# INTERNATIONAL CODE COUNCIL

## 2009/2010 CODE DEVELOPMENT CYCLE

### PROPOSED CHANGES TO THE 2009 EDITIONS OF THE

**October 24 2009 – November 11, 2009**

**FIGURE 1609**  
**BASIC WIND SPEED (3-SECOND GUST)**

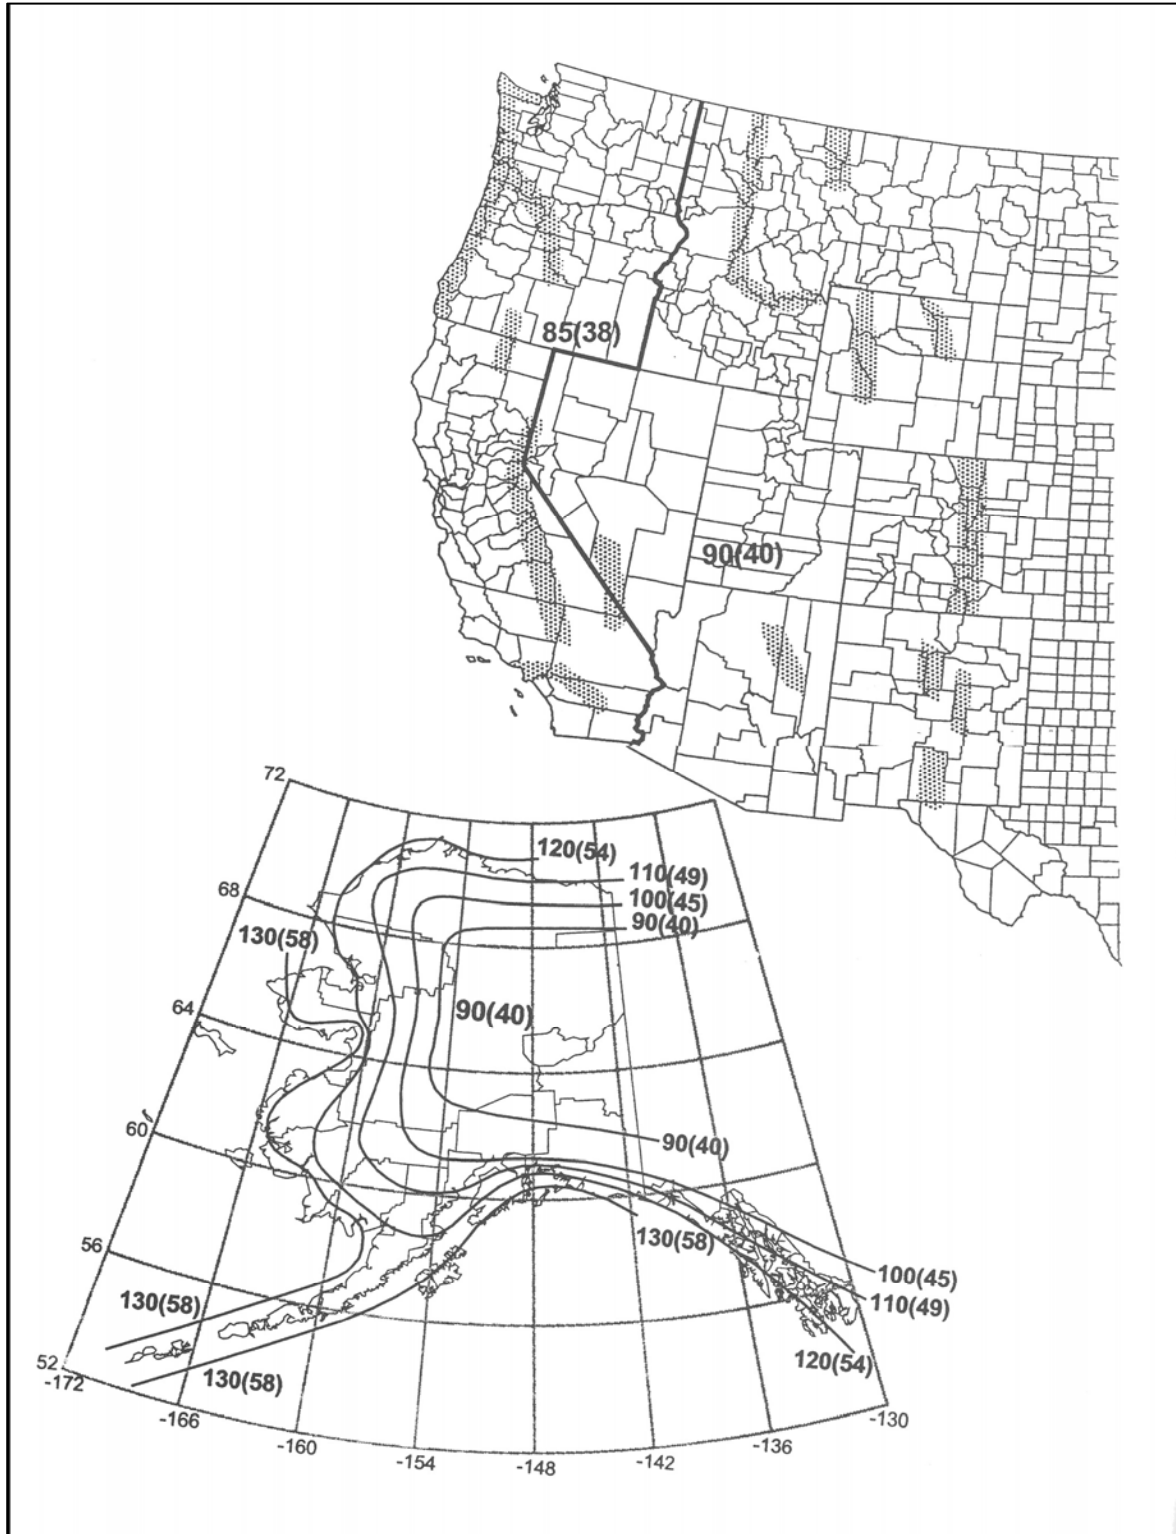
**FIGURE 1609A**  
**ULTIMATE DESIGN WIND SPEEDS,  $V_{ULT}$ , FOR OCCUPANCY CATEGORY II BUILDINGS AND OTHER STRUCTURES**

**Figure 1613.5(1) Maximum Considered Earthquake (MCE) Ground Motion of 0.2 s Spectral Response Acceleration (5% of Critical Damping), Site Class B**

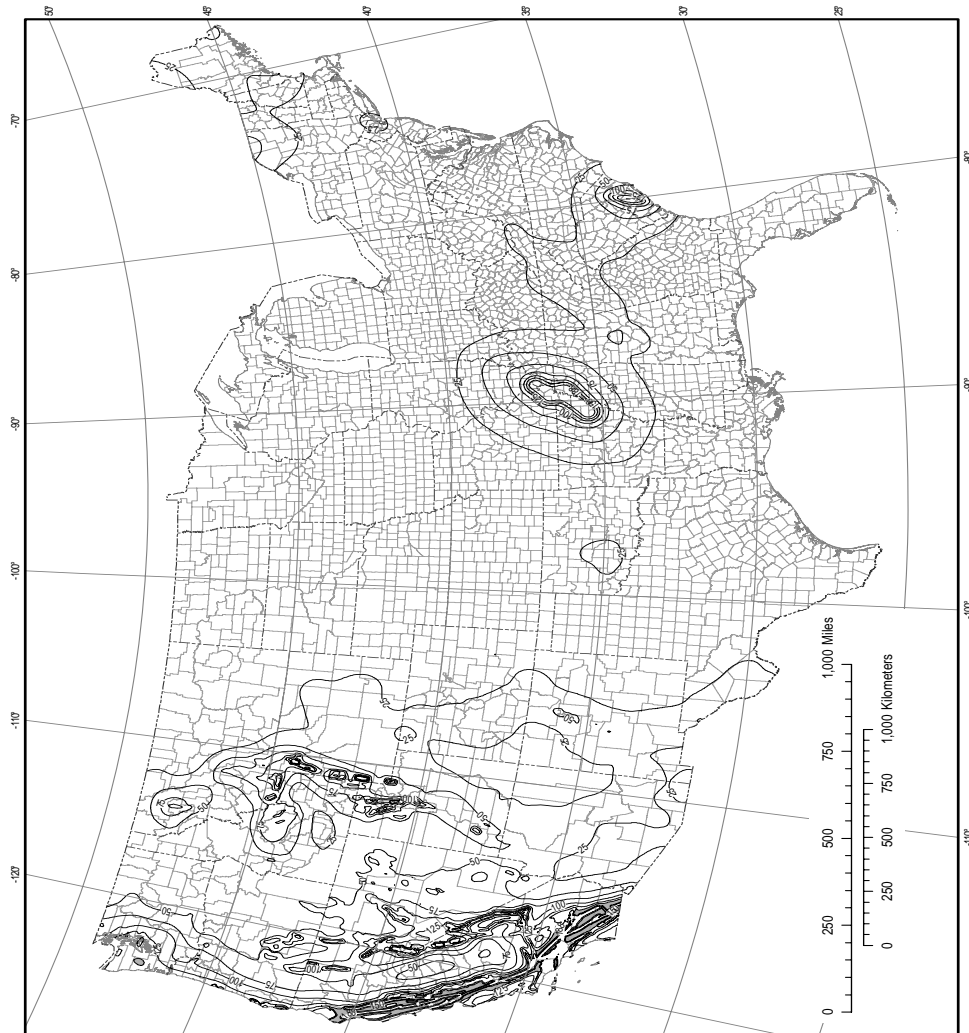
Delete Figures 1613.5(1) through 1613.5(14) and substitute as follows:

**FIGURE A3-1 - NEW REINFORCED CONCRETE FOUNDATION SYSTEM**

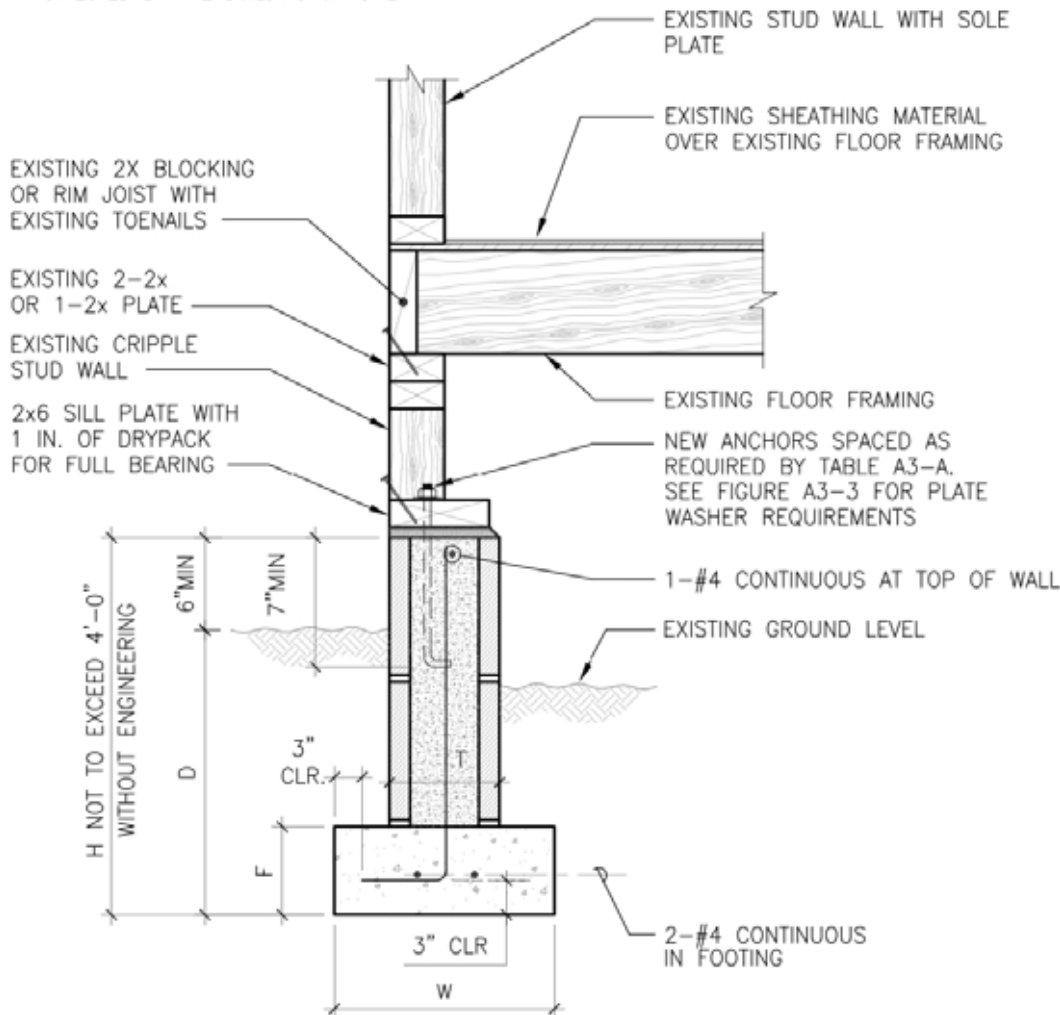
For 2009 Figure A3-2, substitute proposed Figure A3-2

**FIGURE A3-5** - CRIPPLE WALL BRACING WITH NEW WOOD STRUCTURAL PANEL ON EXTERIOR FACE OF CRIPPLE STUDS

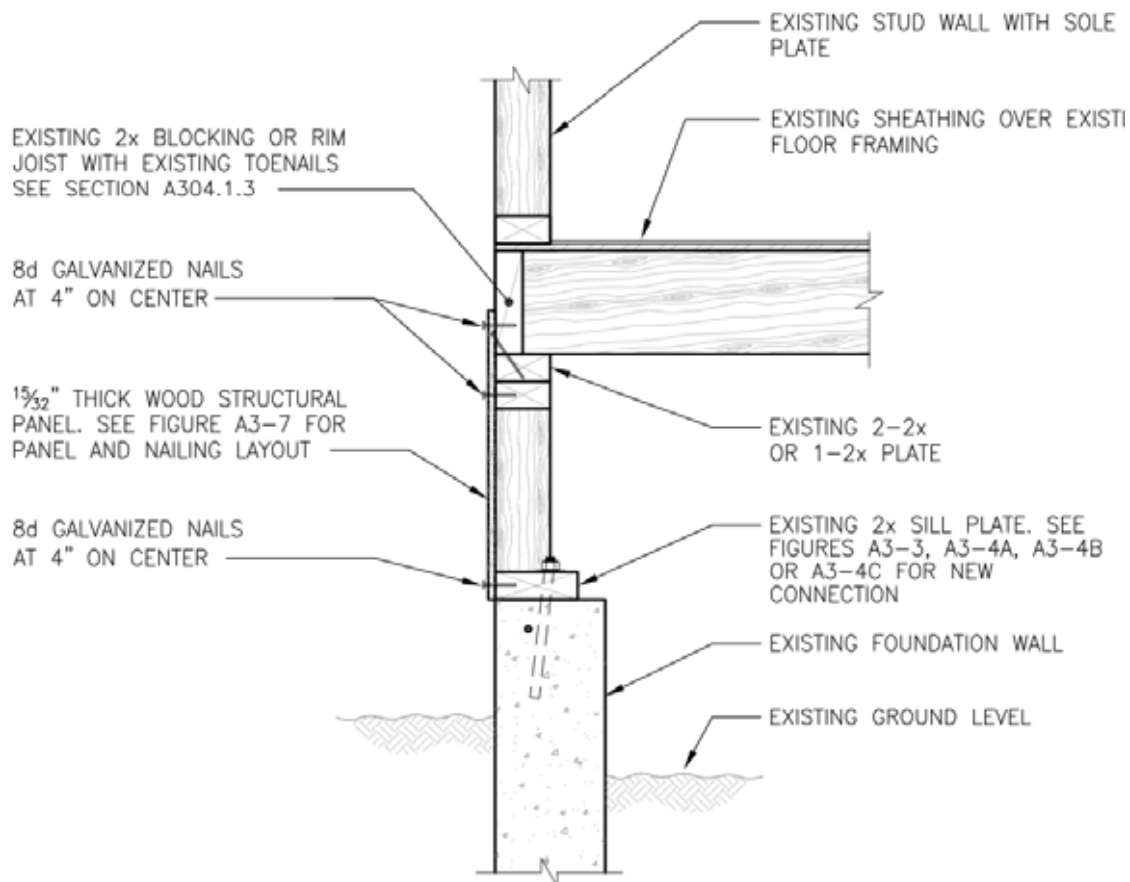
For 2009 Figure A3-5, substitute proposed Figure A3-5

**FIGURE A3-6** - CRIPPLE WALL BRACING WITH WOOD STRUCTURAL PANEL ON INTERIOR FACE OF CRIPPLE STUDS

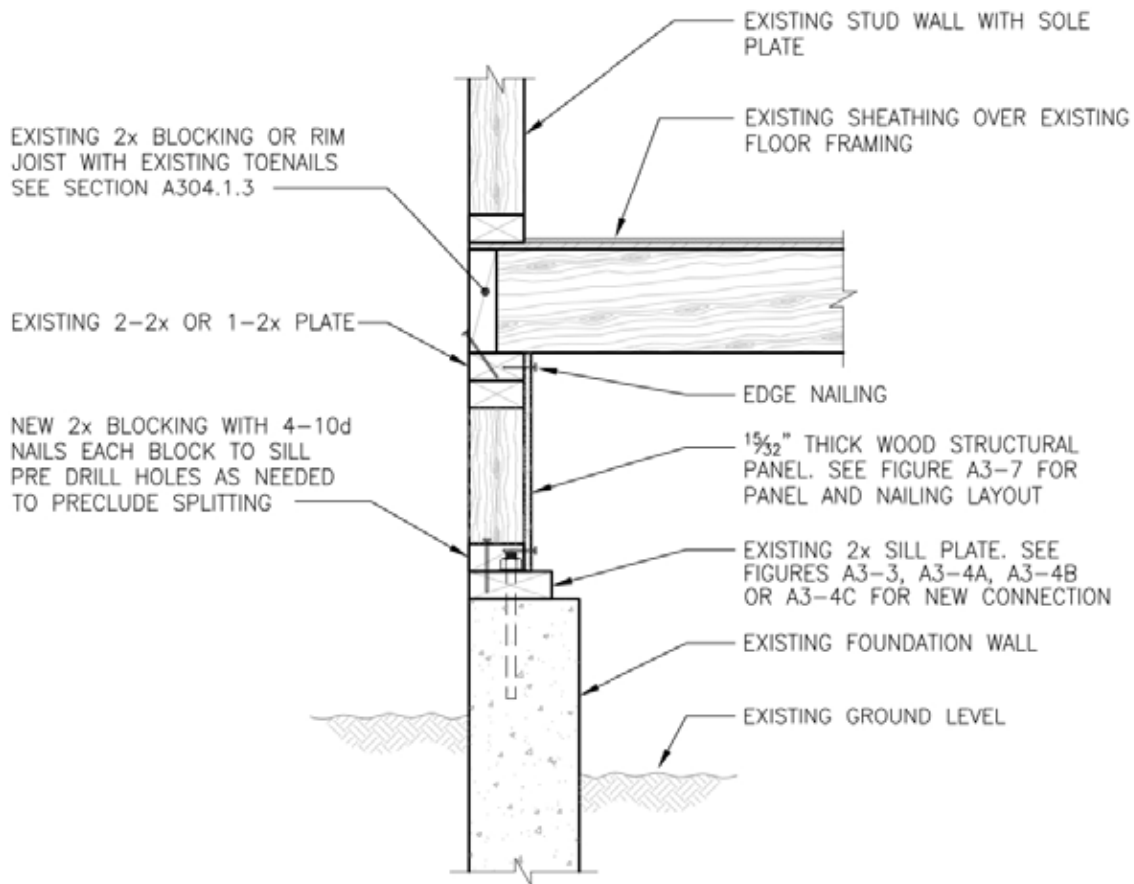
For 2009 Figure A3-6, substitute proposed Figure A3-6

**FIGURE R301.2(4)B**  
**REGIONS WHERE WIND DESIGN IS REQUIRED**

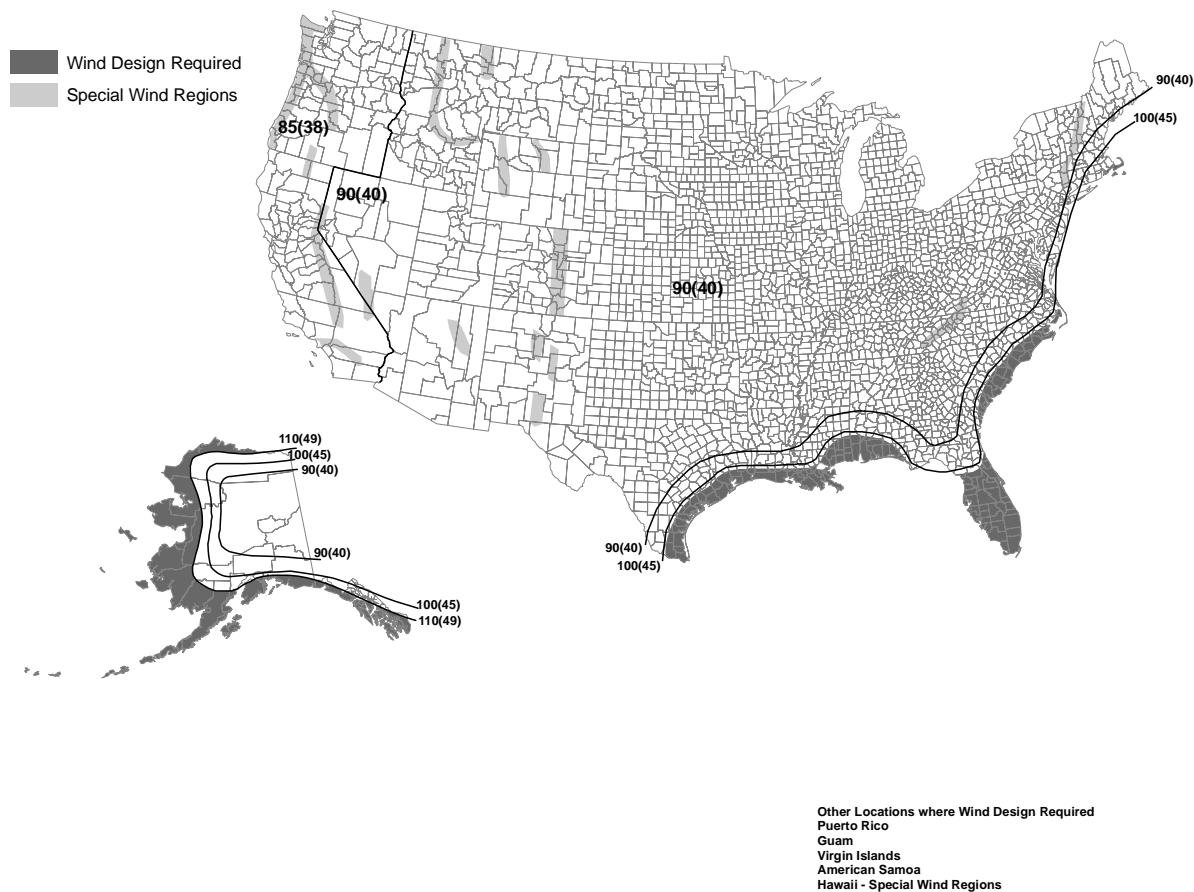
4. Add new figure as follows:

**FIGURE R302.2.1(1)**  
**Example assemblies that can be used to make up a one-hour rated system for separation between occupancies**

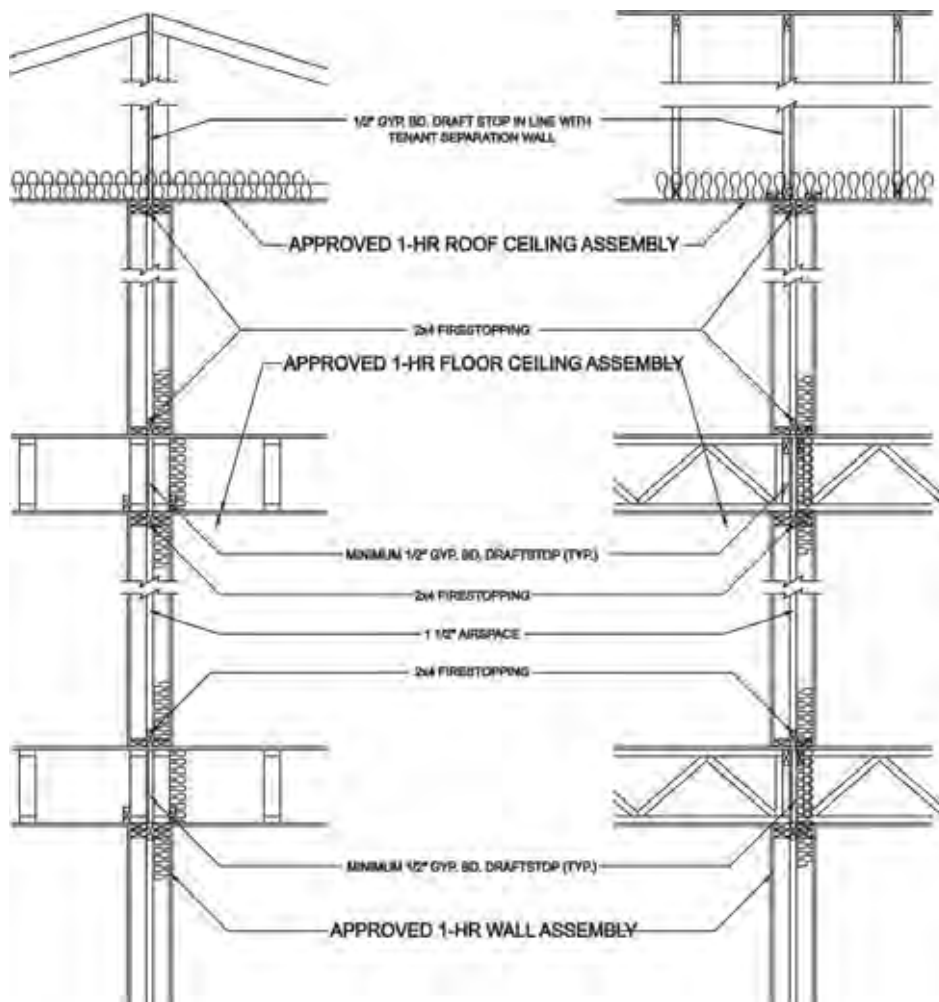
### 2. Add new figures as follows:
